REPORT FOR WATERSHED ADVISORY BOARD

RE: PERMIT APPLICATION NO: 021/19

An application for development has been submitted by Mr. Glenn Hayes on behalf of Matthew and Elizabeth Shearer with regards to Ontario Regulation 159/06 the Development, Interference with Wetlands & Alterations to Shorelines & Watercourses Regulation of the CVCA.

MATT & LIZ
SHEPHERD
COTTAGE
LAKE SIDE

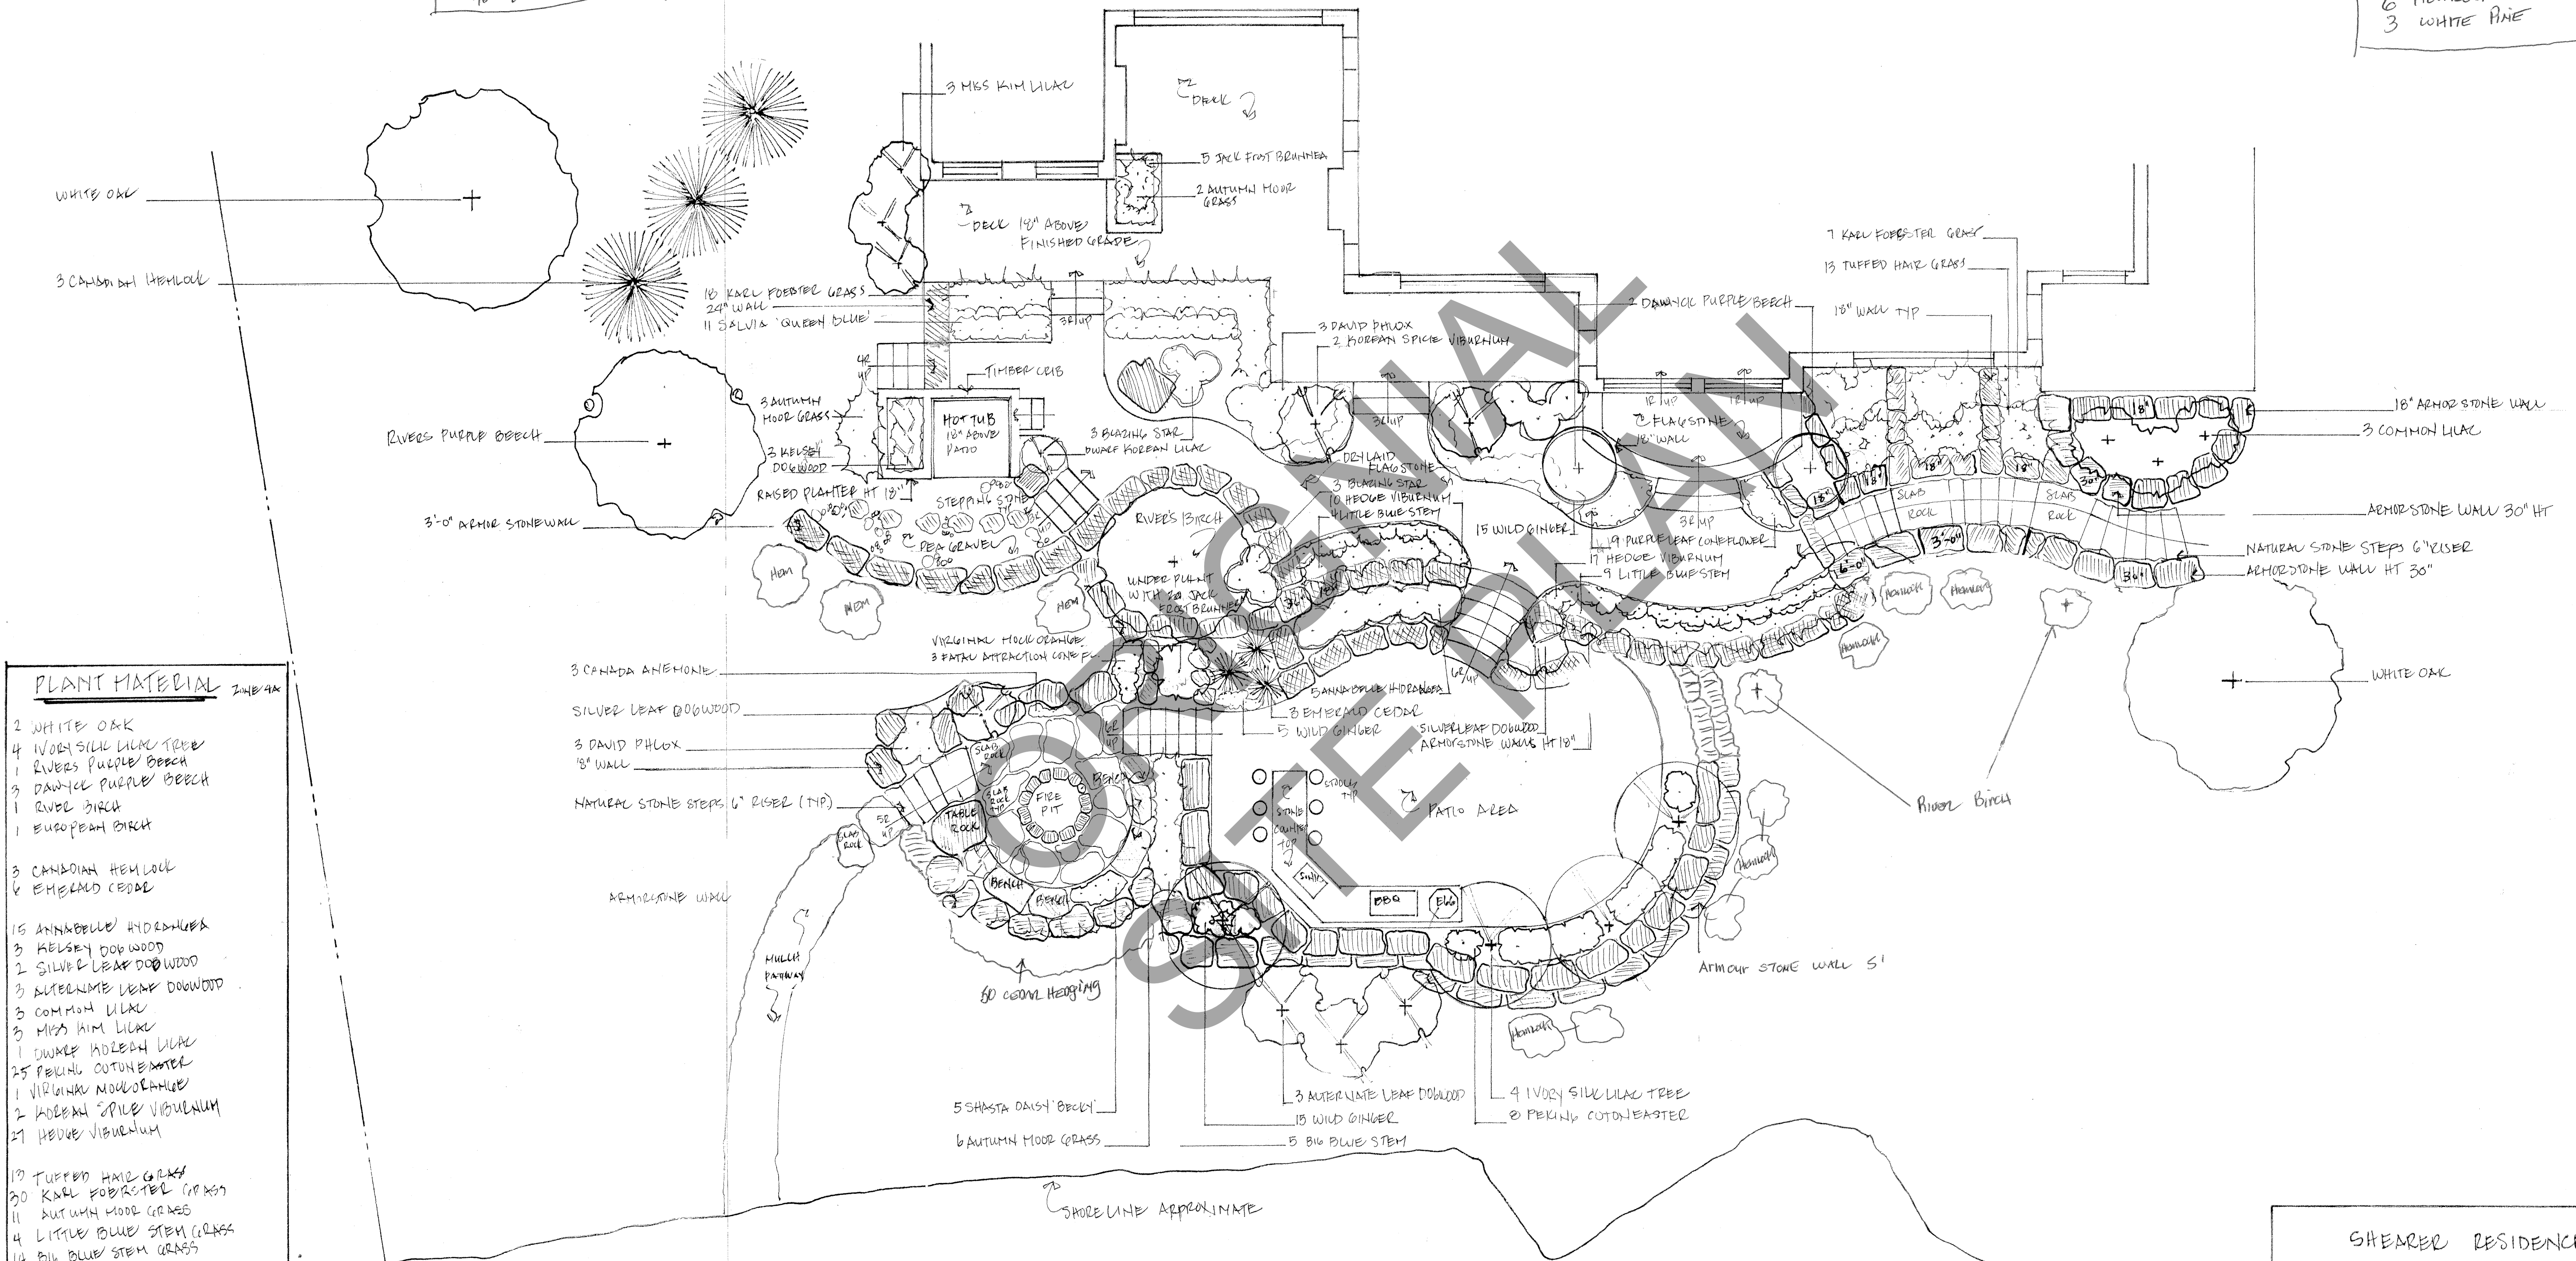
I would like to note that while reviewing the provided drawings I noticed a discrepancy between the setback confirmed on site (and in subsequent phone conversations) versus the submitted drawings. Using the scale, the drawings indicate a 14' (4.27m) setback from the base of the landscaping to the shoreline. My assessment of the file has been using the 30' (~9m) setback stated by Mr. Hayes, and I recommend that an update to the drawings be done to accurately demonstrate the 30' (~9m) setback.

On the map below I extrapolated the drawings onto an air photo. Included is an approximation of the southern extremity of the proposed landscaping (the orange line), but moved it back to the 30' (~9m) setback as stated by Glenn. Developing a trail down to the lake for access to the dock/swimming is permitted but would be limited to 1.8m wide (6'). The more extensive works involving fill placement, excavation, and retaining walls are not permitted within the setback. The red line shows the 15m (50') setback from the shoreline and the blue line shows the shoreline as observed. Please keep in mind many of the setbacks shown initially on our mapping are for demonstration purposes and generally require field verification.

Based on the 15m setback the first option would be to have the landscaping redesigned to keep all development (except the trail down to the dock) outside of the 15m setback and submit a revised drawing. This could be accomplished by moving the bulk of the landscaping to the west of the proposed development and some to the east. Expansion to the east would be limited by the 15m setback to the wetland (not shown on map) that is between the north and south shoreline, isolating the high point to the east.

SHEARER RESIDENCE
CHABOS LAKE, APSLEY ONTARIO
LAKE SIDE LANDSCAPE PLAN
SCALE: 1/2" = 1'-0"
DATE: AUG 2018
DESIGN BY: MARLENE COMBES

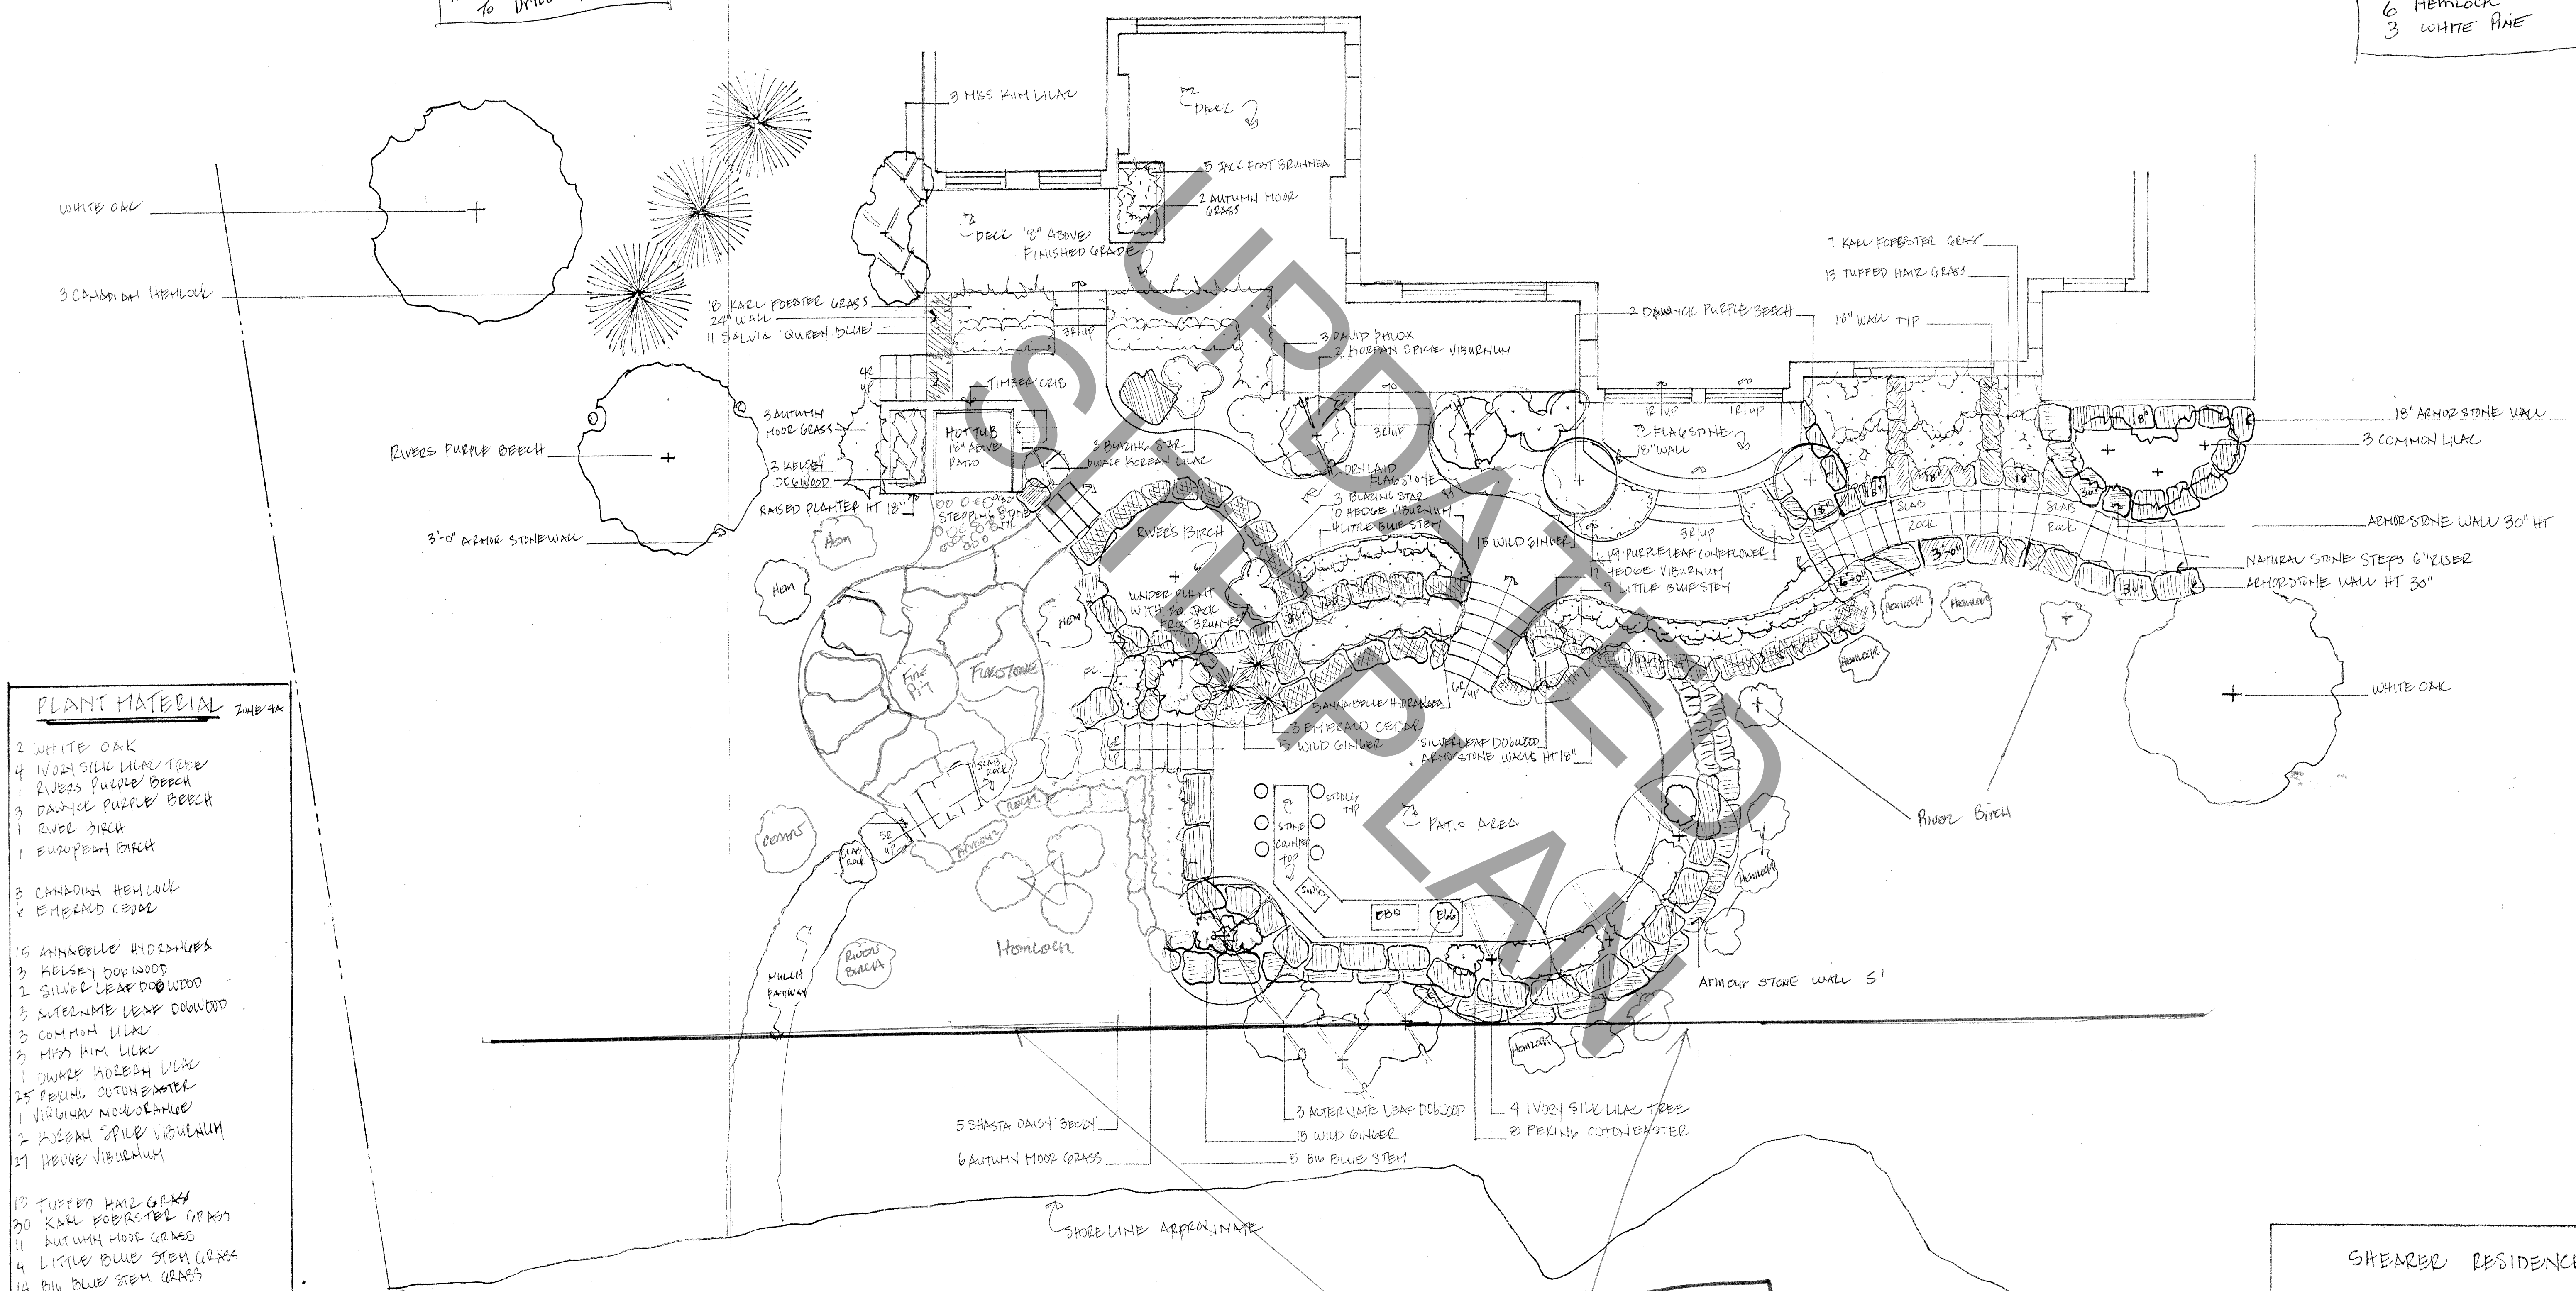
CLOSEST POINT 30' FROM
HIGH WATER FLOOD
LEVEL
ROAD AT ENTRANCE BOWEN
(620)

When started planning we understood that the build line is 30' from the lake so we designed close to that. Our drawing does overlap that line a bit but will make minor changes and keep inside the 30' line. That section on the 30 foot line is only 50' long, both sides set back further from the lake or 30 foot line. To keep low walls we need to go out as the grade keeps getting higher from 30 foot line toward cottage. Then cottage doors are approx 6' above ground at highest point. If we were to keep landscape any closer than 30' that would force us to have less levels. Therefore the walls would be higher. This drawing with multiple levels has drainage in every level and taken off to side so exit of water not close to the lake at exit point.

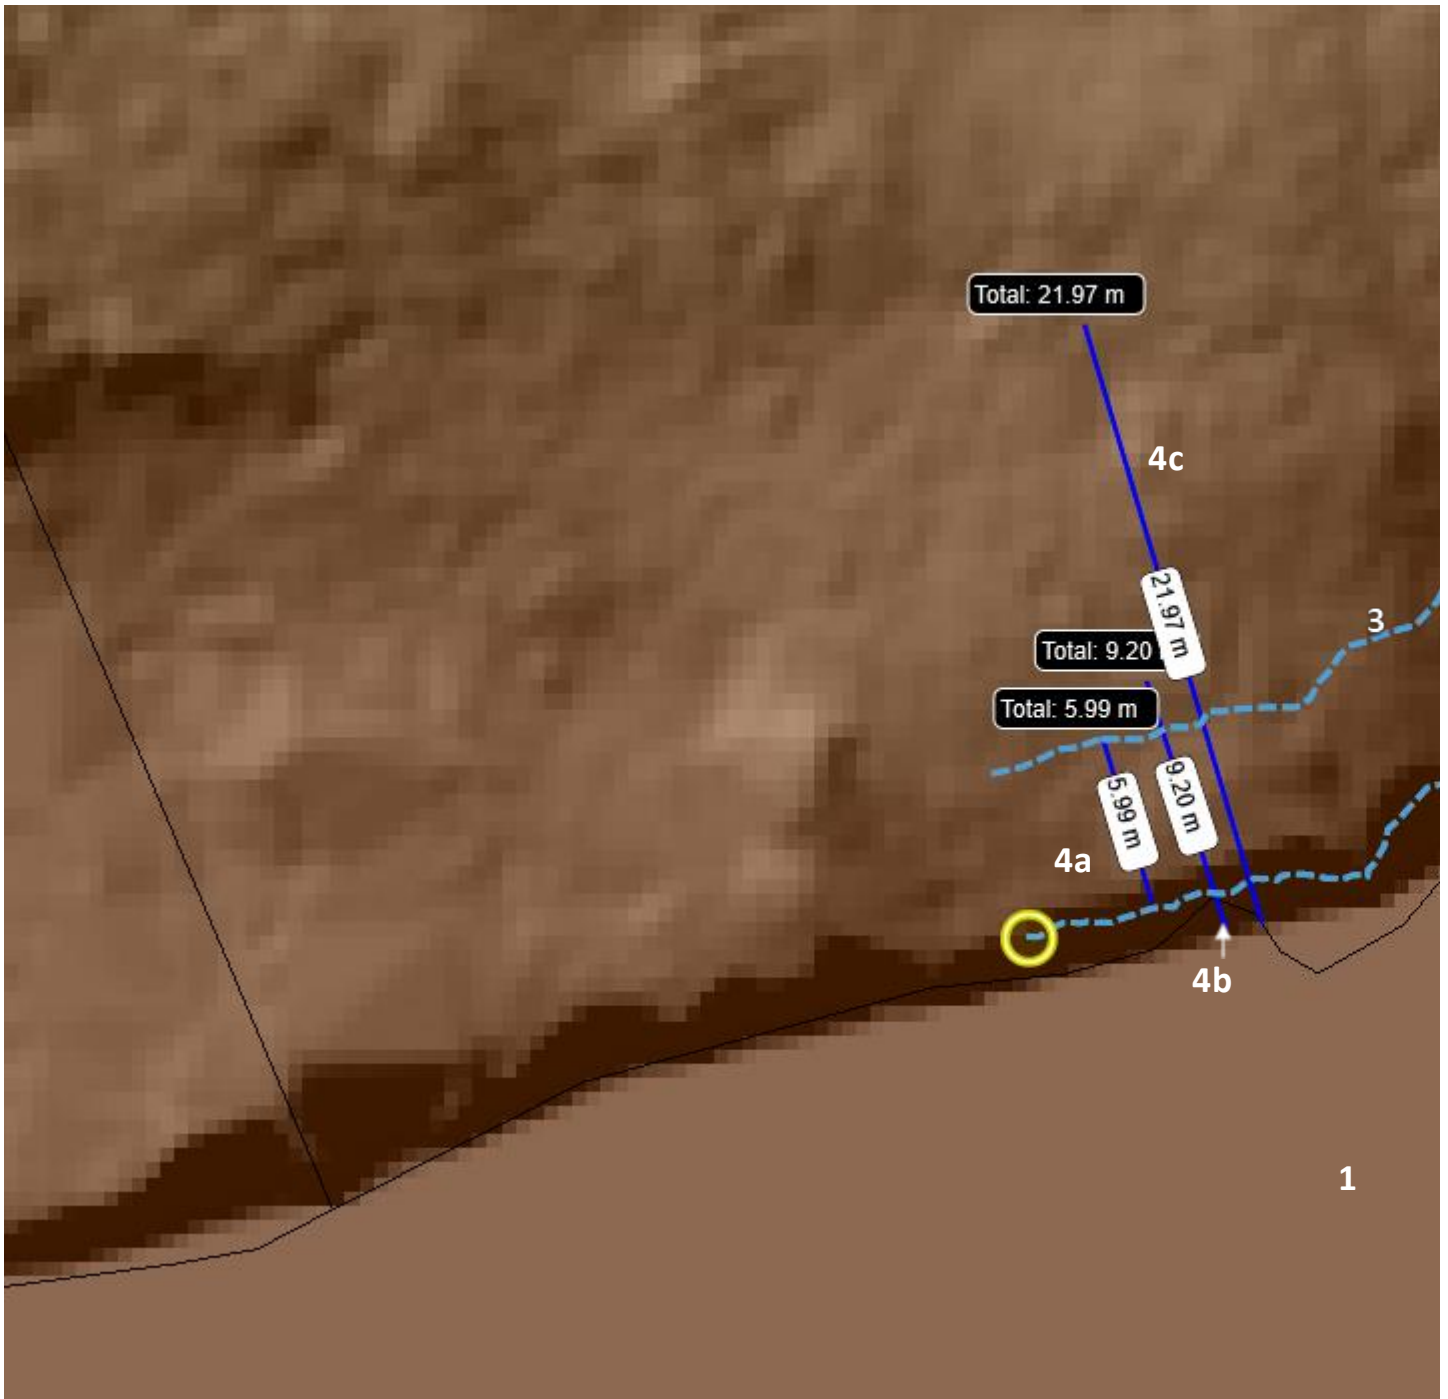
Finally, the CVCA is currently working with several stakeholders and are in the preliminary stages of determining whether floodplain delineation is feasible on Chandos Lake. Below, I have included a map depicting the following:

- 1) The lake (flat monotone copper color);
- 2) The floodplain location at the assumed 314.5MASL (the first light blue hashed line)
- 3) The floodplain setback 6m back (the second light blue hashed line); and,
- 4) Dark blue lines measuring the distance between:
 - a. The floodplain and setback (labelled 5.99m);
 - b. The shoreline and 30' setback for the landscaping (labelled 9.20m); and,
 - c. The shoreline and approximately the closest point of the house (labelled 21.97m).

This map was created using the Peterborough County LiDAR elevation data so is a different color.

This map shows there is a fairly steep shoreline from the west property line towards the wetland(labelled). As such the floodplain, if at the expected 314.5MASL, is between 1-2m (3-6') from the water line. Therefore, the floodplain would be between 7-8m (23-26') feet from the shoreline. A such the proposed 30' (~9m) setback to the water is between 1-2m (4-6') outside the floodplain setback of 6m/~20'. As the shoreline approaches the wetland the grade becomes more gentle and the floodplain will move farther away from the shoreline.

In short, if the accuracy of our predicted floodplain was verified, the proposed landscaping works at 30' from the shoreline could be permitted. However, this would require patience on your part in order for the floodplain to be delineated through an engineered study.
